PRODUCT UPDATE

Written by | LEMO USA | November 2025 | #235

PCN-099
EJG.1B Outer Shell Modification

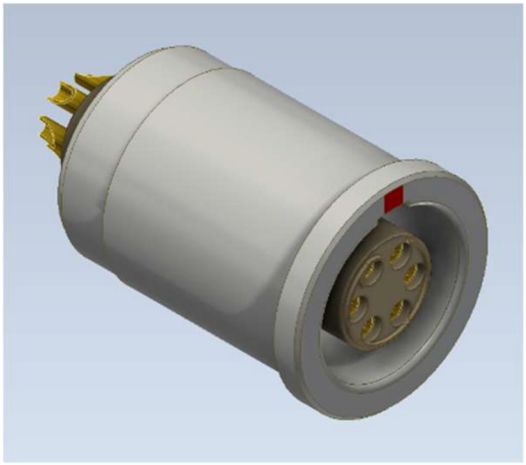
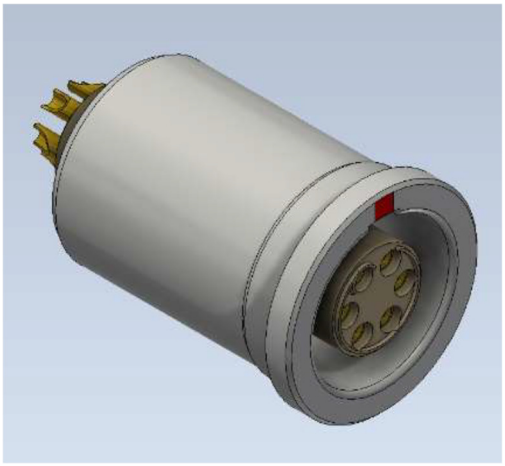
The outer shell of the EJG model in the 1B Series will be modified to slightly increase the friction-fit diameter, and reduce the length of friction-fit diameter to make it easier to install the receptacle into the panel hole.

The outer diameter of the housing changes from 11.2mm to 11.21mm, and the friction-fit diameter length changes from 11.7mm to 2.3mm.
